DOCKET 50-312
RANCHO SECO NUCLEAR GENERATING
STATION UNIT NO 1
HIGH PRESSURE INJECTION NOZZLE
CYCLES

FIELD CHANGE AUTHORIZATION

FC-0174-00

TITLE HPI Nozzle Usage Factor

FIGURE 8-14
TRANSIENT NO. B (REACTOR TRIP)
MAKEUP FLOW AND TEMPERATURE - MANUAL
ACTUATION OF HIGH PRESSURE INJECTION SYSTEM

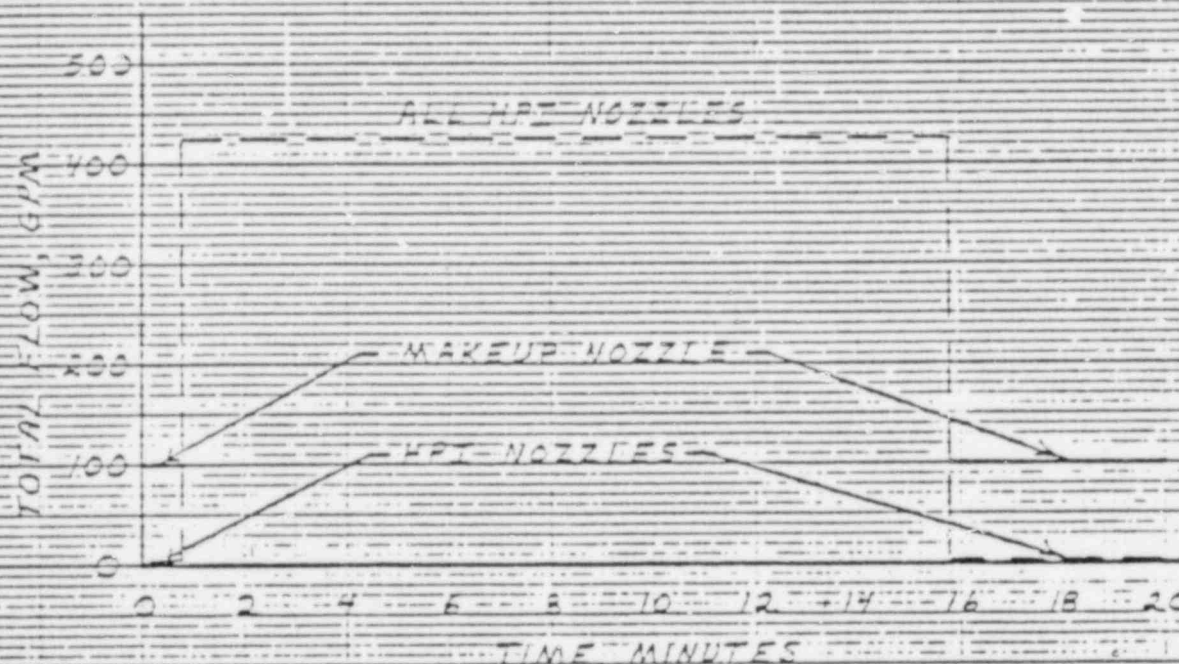
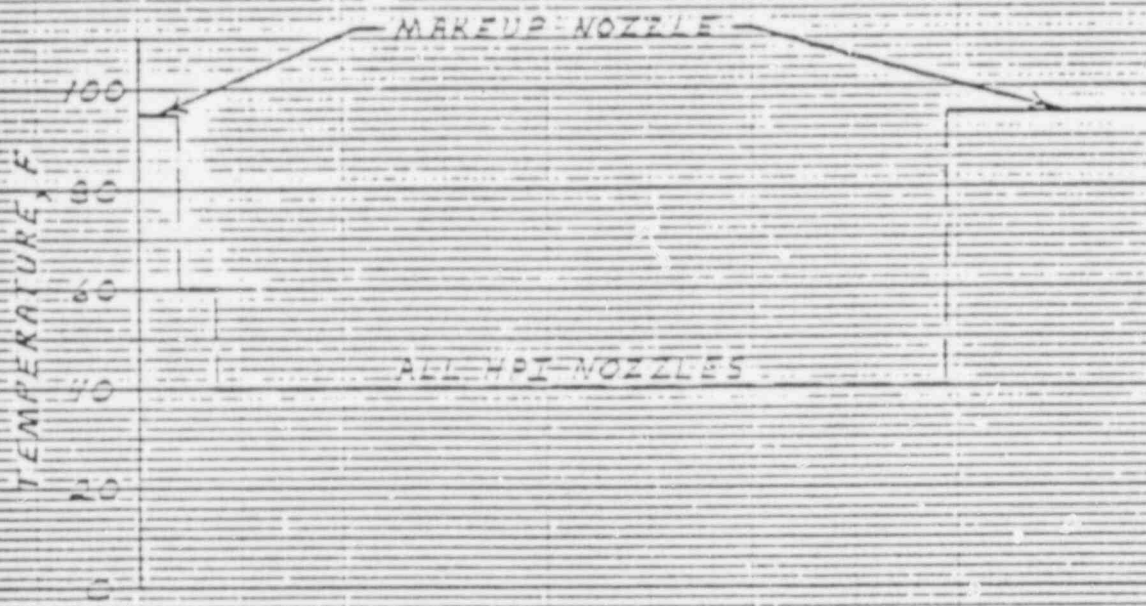
1. A revision to Section 6.9, Transient 8 - Reactor Trip. Specifically, paragraphs will be added to sections 6.9.2 and 6.9.3.1 of the text to provide for manual actuation of the high pressure injection system after a reactor trip.
2. Table 2 will be revised to include 70 design cycles for the above noted change.
3. Figure 8-14 will be added to the spec.

Manual Actuation of High Pressure Injection System After Reactor Trip - Figure 8-14

Occasionally after a reactor trip, it may be necessary to manually actuate the high pressure injection system in order to obtain additional makeup flow. This should only be done to prevent the loss of indicated pressurizer level during the transient. For the total of 400 reactor trip events, an allowance of 70 cycles of high pressure injection system actuations shall be considered for design purposes.
